SERVICE BULLETIN NO. MSB 817-50

ATA-Code: 24-10
 DC - Generation

G 109B

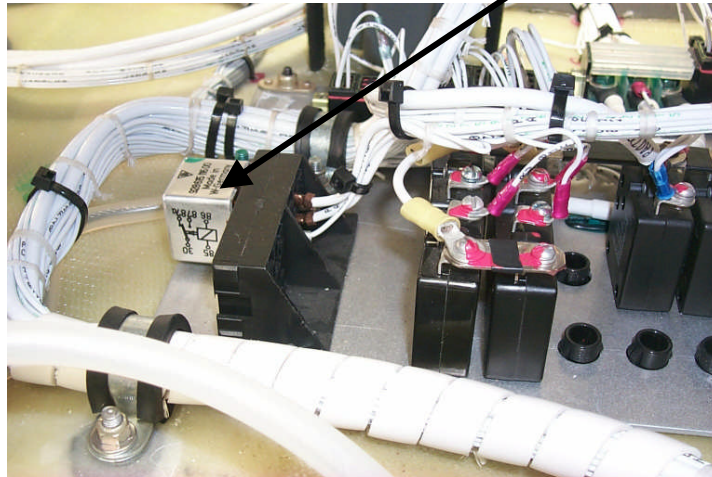
GROB received isolated reports, that relay 6ED was found damaged due to overheating. The relay 6ED is located in the lower RH cockpit instrument panel. Possibly, installation of additional optional electrical equipment may heat up the relay, failure of the lighting system or load bus may result. To cater for increased electrical load the installation of a 30A relay becomes mandatory.

- 1.8.1 Ensure that the aircraft is safe for parking I.A.W. MM.
- 1.8.2 Lower RH cockpit instrument panel and locate relay socket 6ED.

- 1.8.3 Remove and discard relay 6ED.
- 1.8.4 Examine all adjacent wiring for damage and / or signs of over heating. Damaged wiring is to be replaced.
- 1.8.5 Install new relay 6ED P/N V23134-A52-C643.
- 1.8.6 Install and secure RH cockpit instrument panel.
- 1.8.7 Do a functional check.
